Tritax Symmetry (Hinckley) Limited  
**HINCKLEY NATIONAL  
RAIL FREIGHT INTERCHANGE**

**The Hinckley National Rail Freight  
Interchange Development Consent Order**  
Project reference TR050007

**Applicant's response to Deadline 5 Submissions [part 10  
- Residents Businesses]**

Document reference: 18.19

Figure 1: Daytime noise levels from rail traffic, dB LAeq,16h

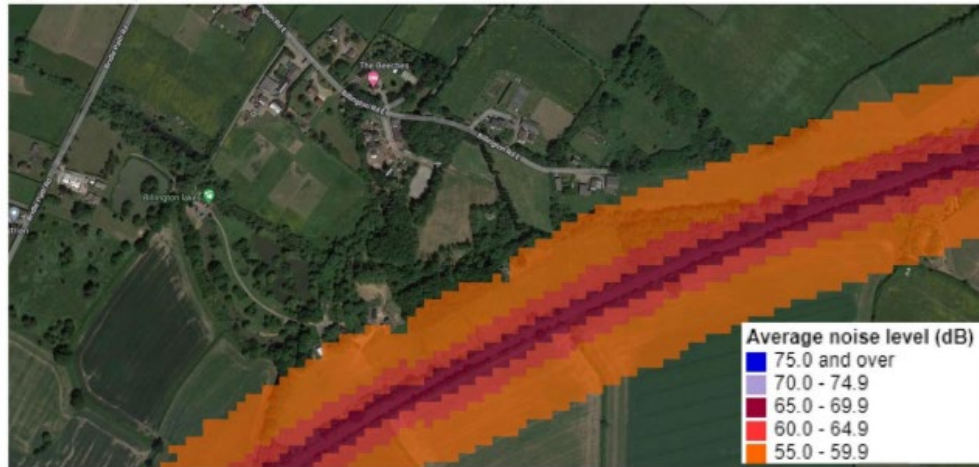
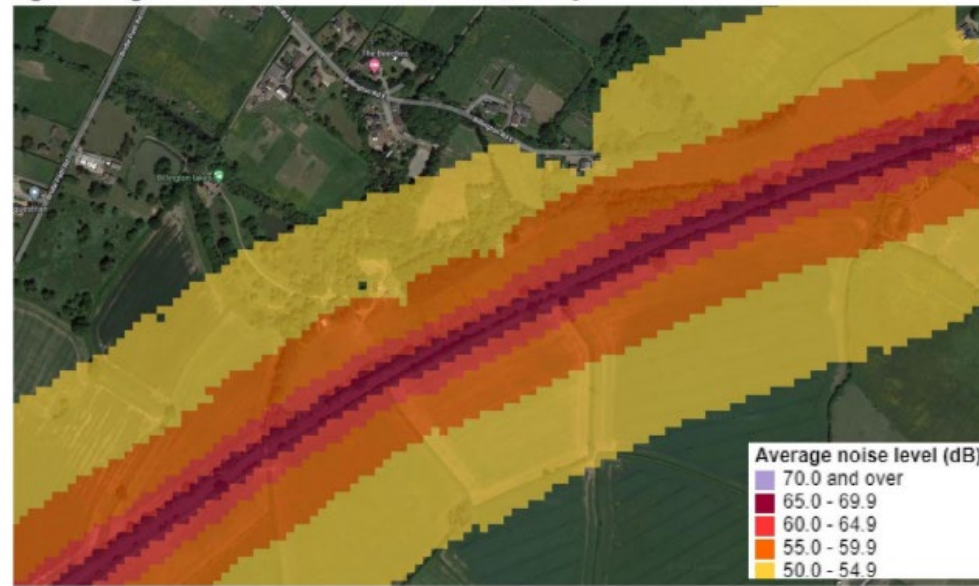
No.	Matter	Applicant's Response
	<p>Further analysis indicates that in comparison with the precise "Gold Standard" Noise measurements performed at NMP4 over a period of seven days, the data in Figures 1 and 2 overstates the Train Noise levels by approximately 12dB during the daytime, and rather more at night-time. So the values in the dB Keys in Tritax's Figures 1 and 2 need to be adjusted downwards by 12dB accordingly.</p> <p>Or, for a visual indication, this means that the width of each of the bands (and therefore the overall width of the noise corridors) shown in Tritax's Figures 1 and 2 should be reduced by a factor of twelve. This, I believe, contracts the whole of the noise corridor banding shown in Figure 1 down to a narrow ribbon that is fully contained within the boundary of the railway property.</p> <p>A yet further failing of the DEFRA Rail Data that Tritax seek to introduce in their Update Note is that it provides no information in respect of the much quieter periods of the weekends, and especially the weekend night-times, when very few, if any, trains run, and when the contours Tritax have shown will simply disappear because there is no Rail Noise at all.</p> <p>Now, in their Noise and vibration report proper, Tritax referred in their Paragraph 10.252 and their Footnote 41 to the Extrium website and to the Strategic DEFRA mapping, and stated "the DEFRA mapping is produced at a strategic level and therefore not accurate enough to design against". But Tritax have obviously not thought fit to repeat that warning when they seek to actually introduce this data in their Update Note. And were Tritax aware of this discrepancy when they wrote their Update Note?</p>

No.	Matter	Applicant's Response
	<p>Whatever the answer to that question might be I think that, at root, the problem lies in trying to use general guidance data for a purpose for which it was never intended.</p> <p>Finally, in order to underline the point I made earlier concerning the <b>uniformity</b> of the Rail Noise over the length of line we are discussing here, I show below an extract from the Extrium website that displays the daytime DEFRA Rail Noise data over the length of line, extended to include NMP4. The <b>uniformity</b> of the Rail Noise over that whole stretch of line is clearly evident.</p>

No.	Matter	Applicant's Response
	<p>What all this means in practical terms is that, in Tritax's Update Note, Table 4, the values shown in the second column headed "Indicative Rail Traffic dB LAeq,T" are all invalid.</p> <p>I have already demonstrated in my Comments Document of the 14th November 2023, and also in my Response to the Examining Authority's Written Questions of the 9th January 2024, that the Attenuation of Rail Noise can be appropriately modelled in accordance with BS4142 and the "Calculation of Railway Noise" (CRN) using the Noise Monitoring NMP4 results that Tritax have already disclosed in their Noise and vibration report proper and their ES Appendix 10.10 "Summary Results". My Response to the Examining Authority's Written Questions also outlines cross-checks that provide strong confirmation of both the NMP4 data itself, and the accuracy of the CRN modelling.</p>	
43	<p><b>Road Noise Data</b></p> <p>Although its provenance seems unclear, it is my understanding that the Road Noise data that Tritax have used in their Update Note has, like their Rail Data, ultimately been sourced from DEFRA. But whereas their Rail Noise data was taken directly from the Extrium website in the ready form of Noise Contour maps, for the Road Noise Tritax have instead sourced the data in the form of Traffic Flows. To use this data, Tritax have then themselves created a Noise Model, from which in turn Tritax have then predicted the Noise Contour maps shown in Figures 3 and 4 of their Update Note.</p>	<p>This was addressed at ISH6 and summarised in the Applicants Written Statement of Oral Case (document reference: 18.15, REP5-025)</p>
